Technical change to RS VERT interfaces

PCN-number: 20211027

Representative RS VERT interface

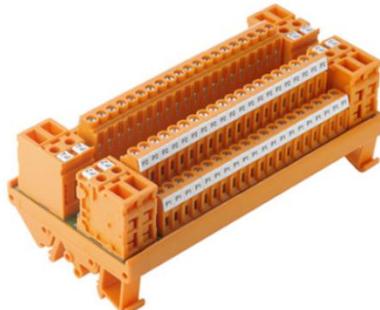
Based on continuous improvement the LP2N and LP3R connectors will be replaced by LL2N and LL3R connectors KSW strip markers.

Old version	Mating compatibility	New version
LP2N 5.0x		LL2N 5.0x/90
LP3R 5.0x/90		LL3R 5.0x/90

Obsolescence of LP2N and LP3R connector range.
